Office Action Summary	Application No. 10/541,138	Applicant(s) MCDONALD, ROSS	
	Examiner Carl D. Price	Art Unit 3749

DETAILED ACTION**Drawings**

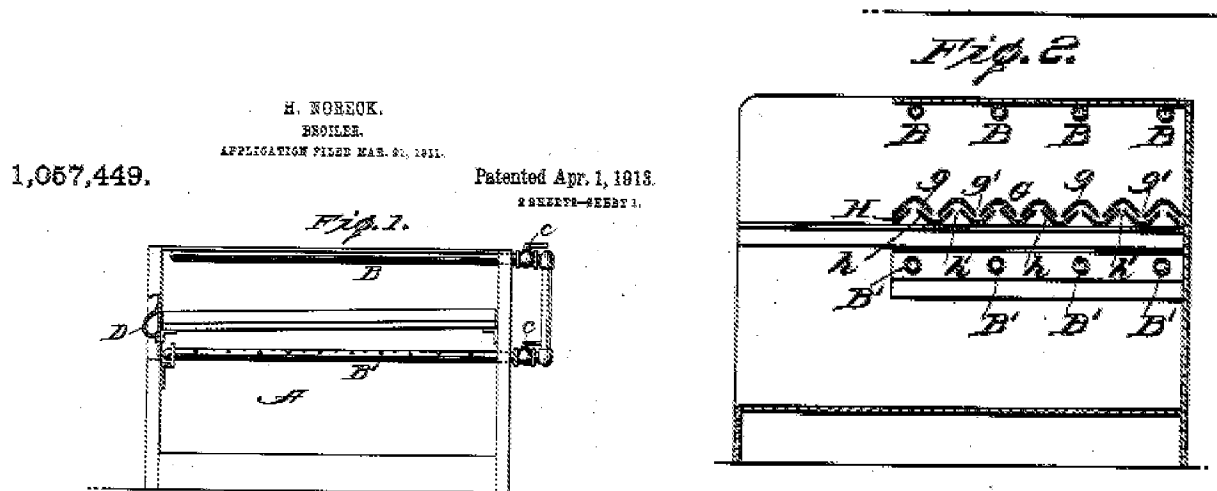
Claims 1, 3 and 10 are rejected under 35 U.S.C. 102(b) as being anticipated by **US 1057449 (Noreck)**.

US 1057449 (Noreck) shows and discloses broiler including a cooking surface having:

- an upper side of a series of parallel closely spaced and inclined bars (g) having a convex upper side and concave underside; and
- a corresponding series of burners (B') extending respectively along and adjacent an underside of each bar so that melted fats or other material falling from or between the bars fall past a combustion zone around the burners and food on the surface is shielded from the radiant heat of the burners.

WO 98/47637

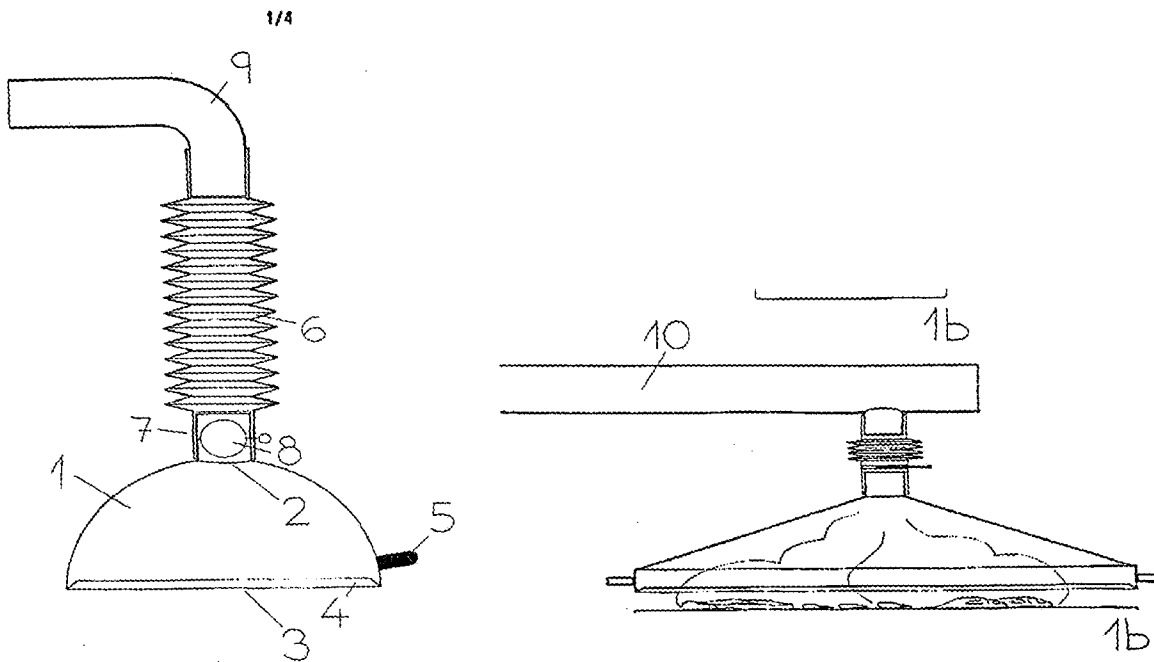
Claims 18-23 are rejected under 35 U.S.C. 102(b) as being anticipated by **WO 98/47637**.

WO 98/47637 shows and discloses an apparatus mounted as an extension of smoke extraction conduits in a kitchen up to the location where the smokes and gas are produced (pans, cookers, etc.). The apparatus is comprised of two bodies: the hood or bell itself (1) which collects the gas and smokes, and a flexible and extensible tube (2) which conducts gas and smokes collected in the bell to the extraction conduits (3). The first body (hood) has an opening (4) through which the gas and smokes can enter, a flange (5) towards the inside of the hood which collects the condensations, another opening (6) through which the smokes and gas can come out to reach the second body, and a handle (7). The second body has a valve (8) which closes the conduit and a junction part (9) for connecting it to the extraction conduits. This apparatus avoids the dispersion of fumes and gas produced by pans and cookers in a kitchen.

WO 98/47637 teaches, from applicant's same cooking appliance field of endeavor, hood (1) to cover at least part of the cooking surface and enclose a cooking region, a vent opening (2) in said hood to provide a passageway for egress from the cooking region, and a manually operated baffle (8) cooperating with said vent opening and selectively operable to

move between an open position in which egress from the cooking region is permitted and a closed position in which egress is substantially prevented.

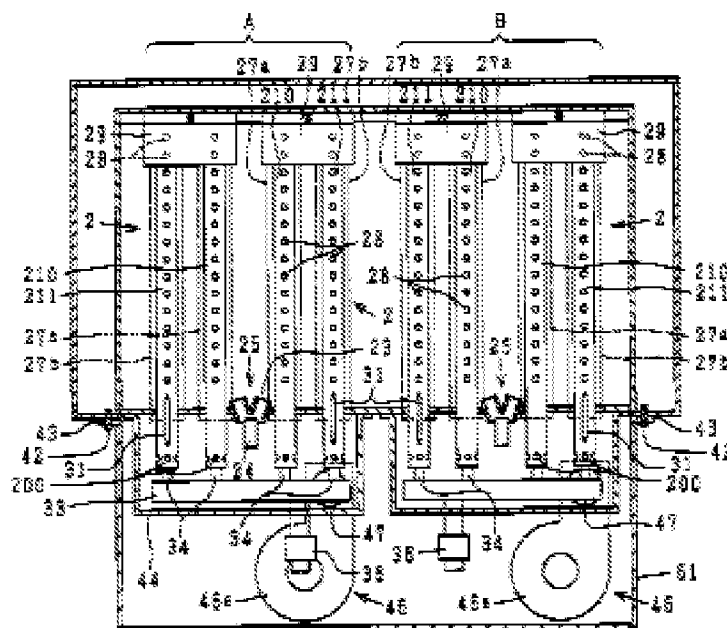
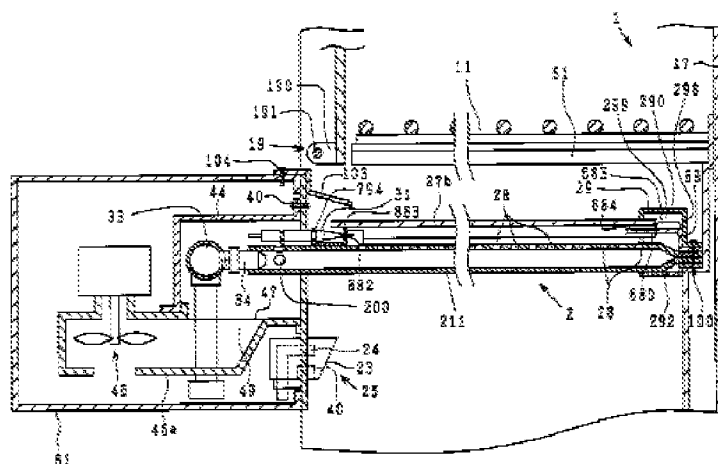
JP 11-211094 teaches, from applicant's same cooking appliance field of endeavor, shows and discloses broiler including a cooking surface having:

- an upper side of a series of parallel closely spaced and inclined bars (27a, 27b) having a convex upper side and concave underside; and
- a corresponding series of burners (28) extending respectively along and adjacent an underside of each bar so that melted fats or other material falling from or between the bars fall past a combustion zone around the burners and food on the surface is shielded from the radiant heat of the burners; and
- a selected number of burners with an interconnected subsidiary manifold (55) with a gas cock (57) supplied from a primary manifold (54) under the control of a single regulator valve (36).

In regard to claims 2, 4, 5, 6, 8, 9, 11 and 14, since the shape of a given bar arrangement, the relationship between the area forming the bars and the spaces there between, the relationship of the flame with respect to the bars, the relative size of the ports along the length of the burner, the cross sectional shape of the burner, the slope of the bars, etc. would necessarily depend on numerous interrelated design concerns such as, the overall size and shape of the burner, the actual size of the flame ports, etc., to form the various aspects of the invention in the manner set forth in claims 2, 4, 5, 6, 8, 9, 11 and 14 can be viewed as nothing more than merely a matter of choice in design absent the showing of any new or unexpected results produced therefrom over the prior art of record. In regard to claim 12, in particular, the recitation “wherein the temperature of the grill bars is controlled to between 280° and 295°C.” is deemed to be merely a statement of intended use and/or method of operating the claimed apparatus which fails to further limit the claimed apparatus in a manner which would distinguish the claimed invention over the prior art of record.
